Proposed Residential Development at the Former Belle Vue Ambulance Site, Gorton

Transport Statement

Appendix C Scoping Note and Correspondence with MCC

Ambulance Site Plan Option A

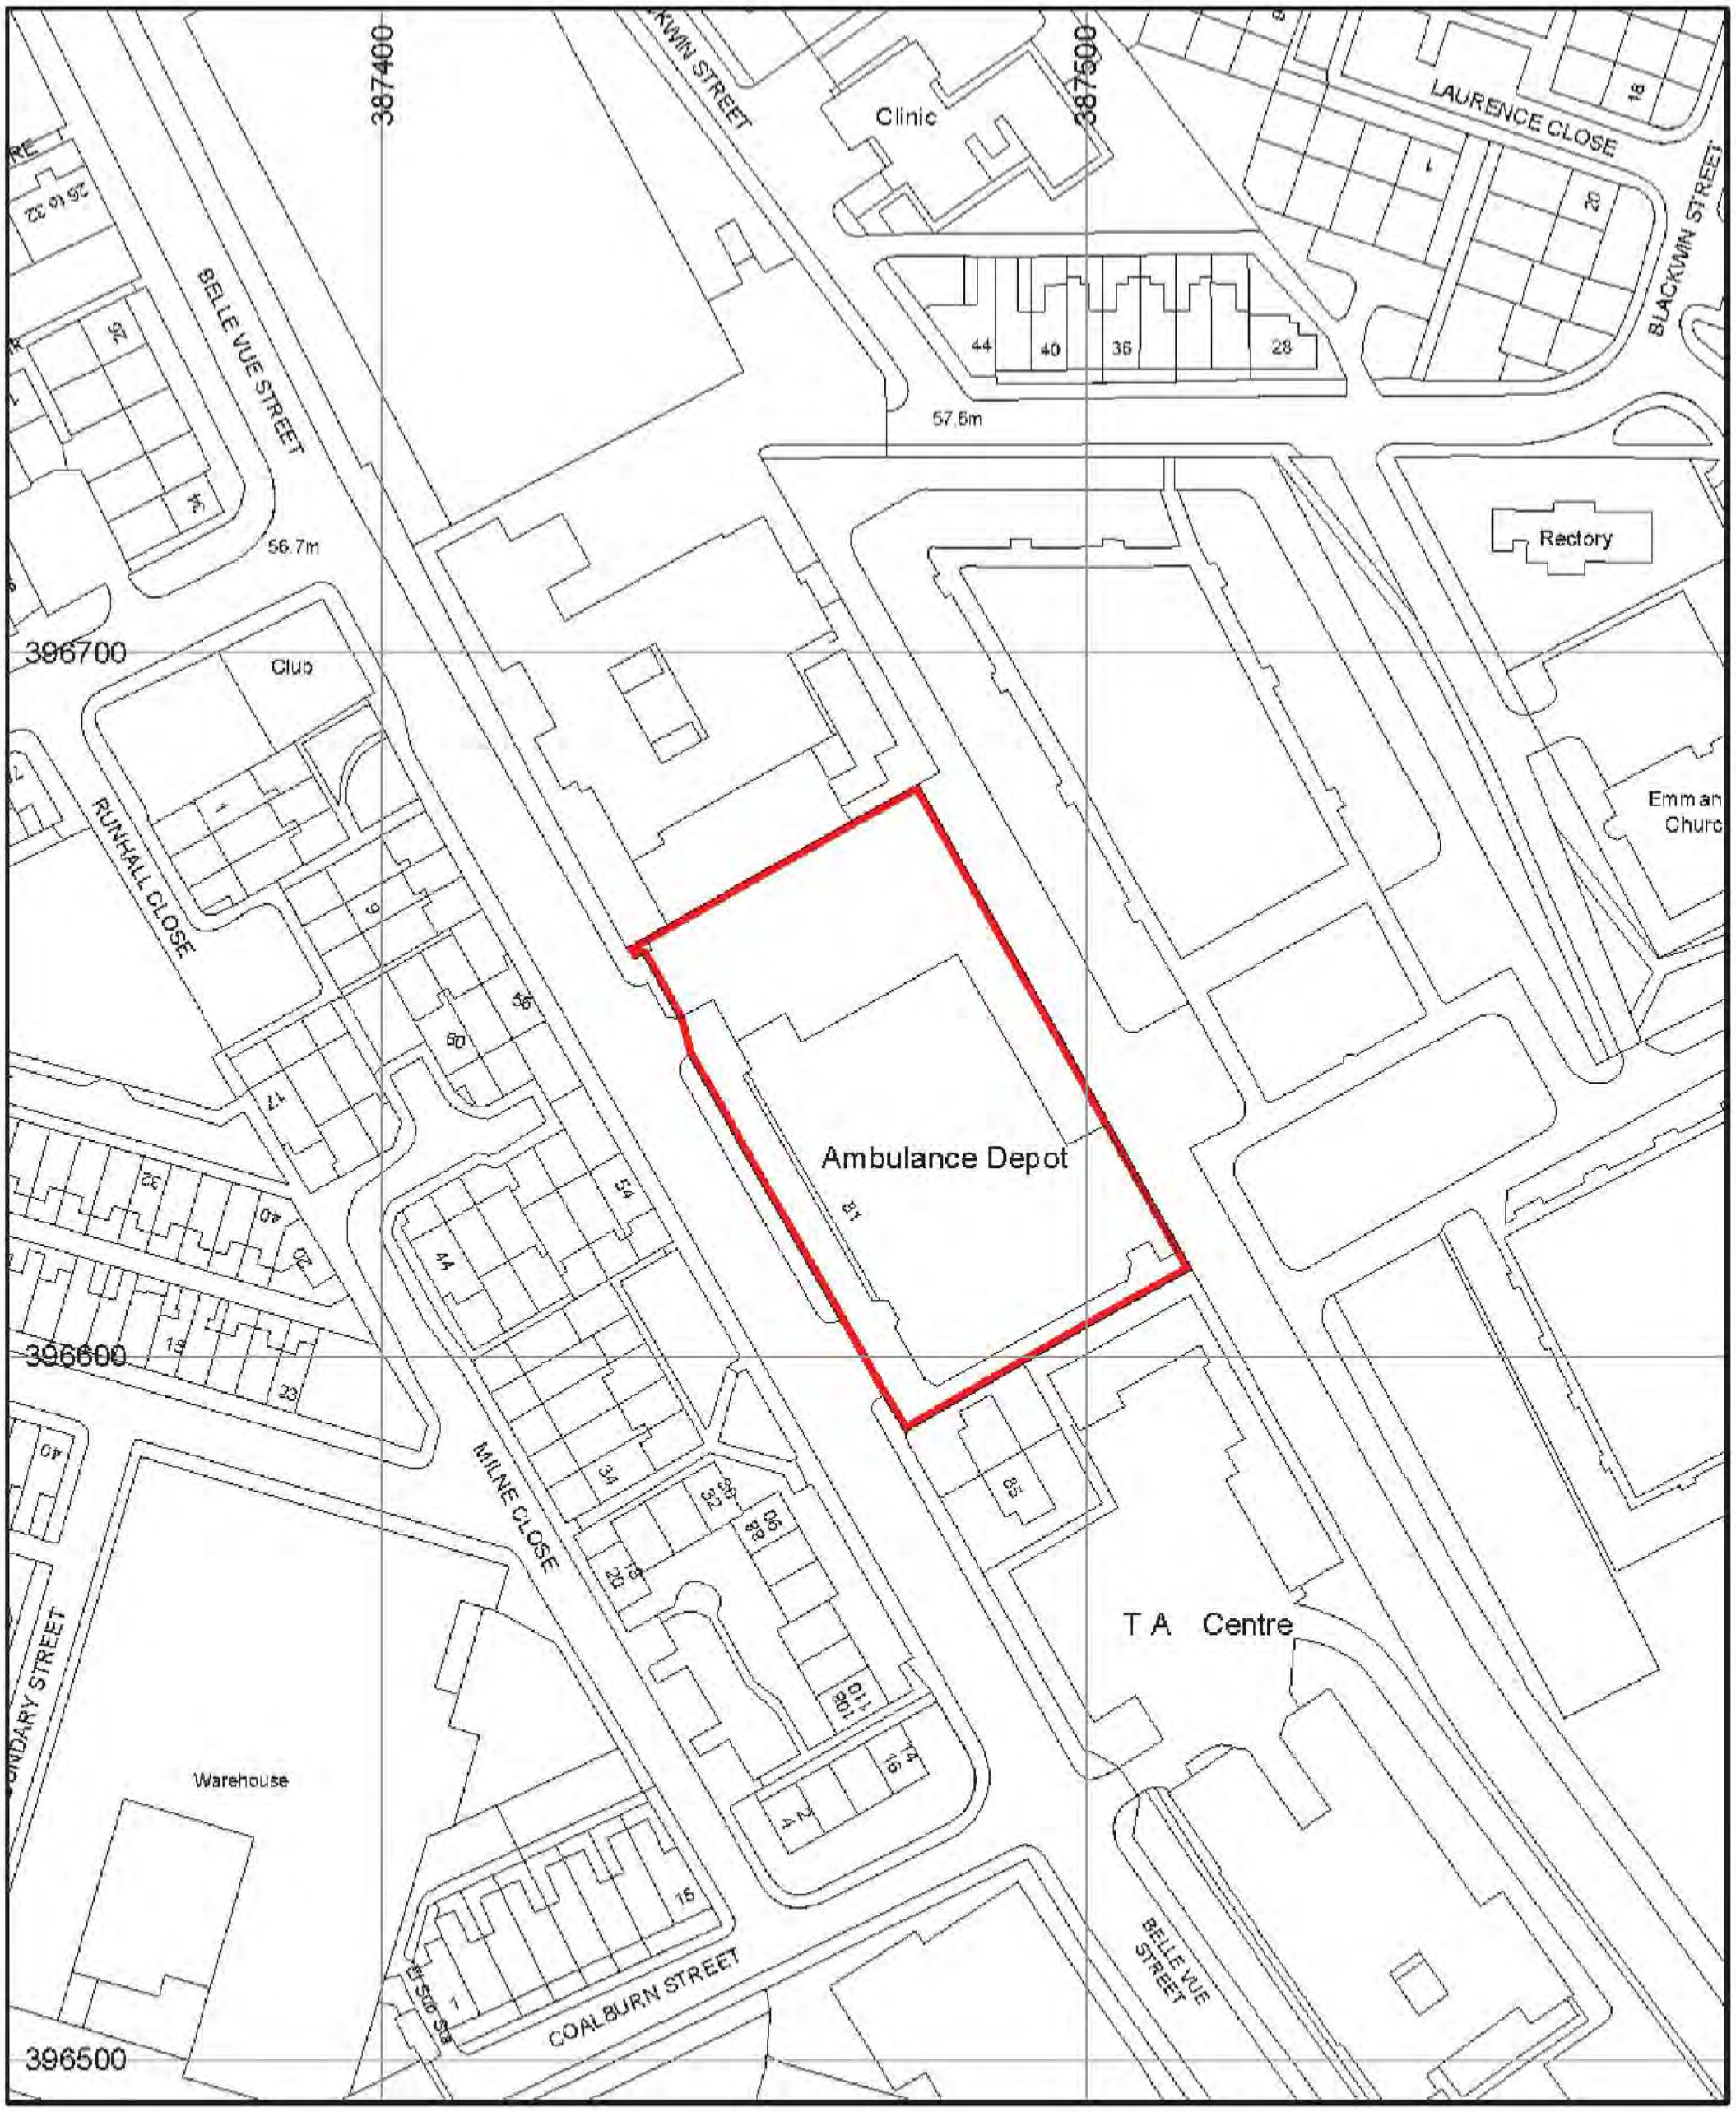
The forwarded masterplan shows an extremely wide section of footway flanking a turning head. Concerns here would include residents and visitors parking vehicles off-street but entirely on the wide footways, damaging the surfaces. Furthermore, these areas a wide and costly to maintain;

One option may be to reduce the wide footways in order to provide visitor parking spaces, however driveway accesses would still be required;

Alternatively the carriageway width could be maintained at 5.0m with a 2.0m wide footway on either side and a 600mm hard-surfaces servicing strip across the top of the cul-de-sac. The property plots along the access road could then be brought forward to either provide larger front or rear gardens. If larger front gardens are provided, additional in-curtilage visitor parking could be provided, potentially without vehicles having to park on-street; and

Ambulance Site Plan Option A

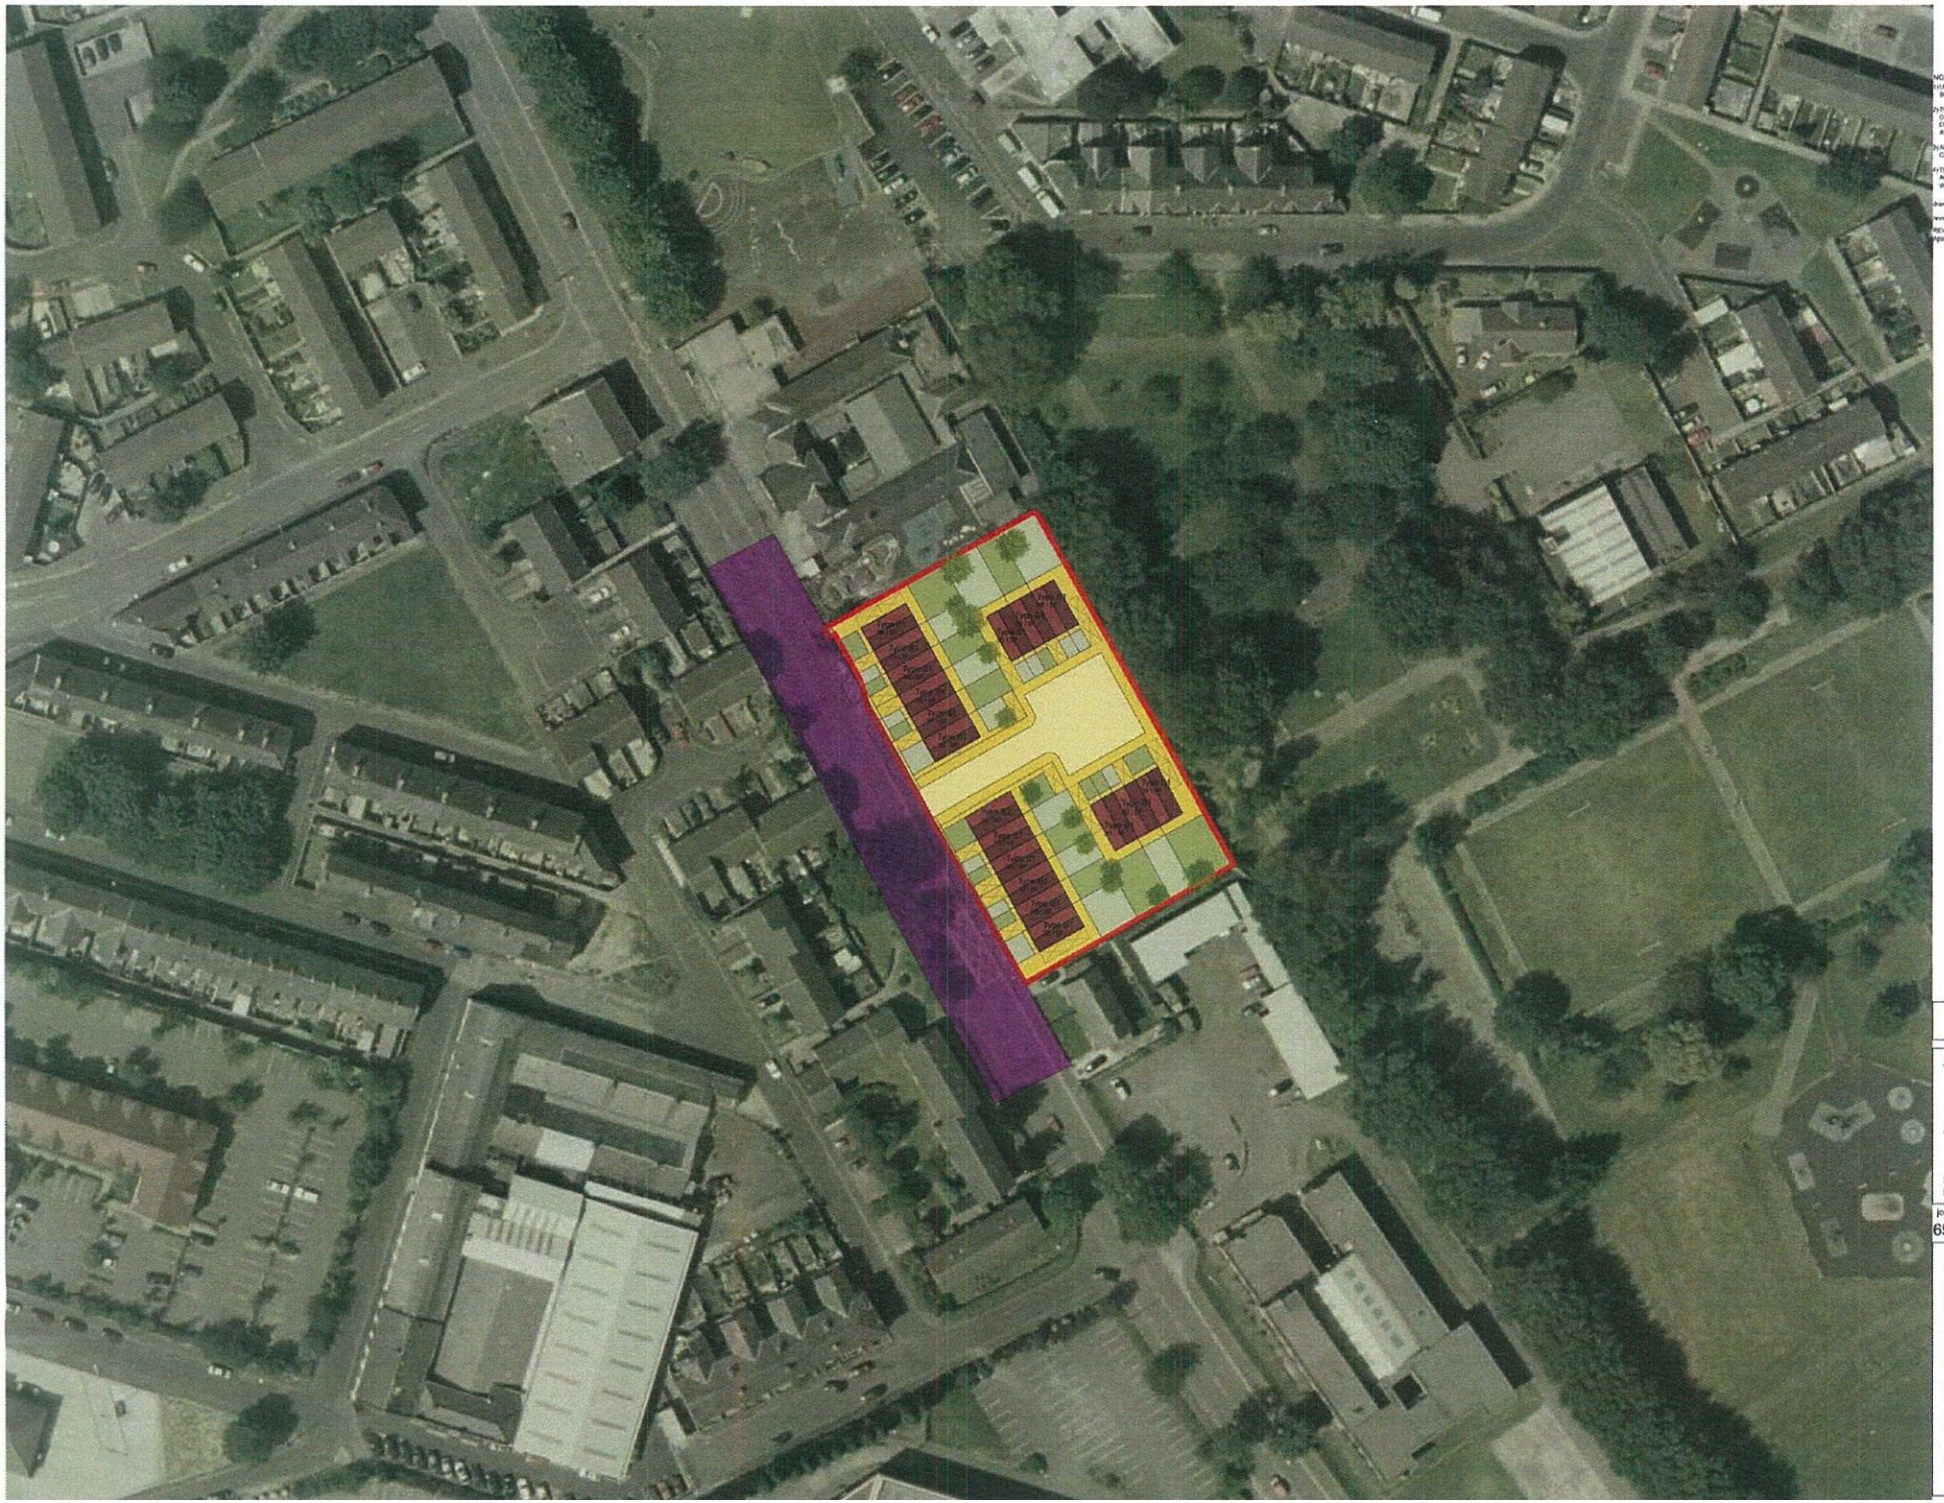
MCC would not typically adopt such a wide area of carriageway, which could potentially be used as a parking Courtyard. However, adopting would be considered if the carriageway was narrowed to around 5.50m width with a 2.0m wide footway on either side. It is understood the feature may be to provide a turning head for Refuse Collection Vehicles, however, given the length of the access road from its junction with Belle Vue Street, a turning head may not necessarily be required. I also not the middle plots of the two blocks of three properties would not be able to move waste bins from the rear of the property to the collection point along the access road as the only access routes shown on the forwarded plan run through the end plots driveway accesses and parking spaces.
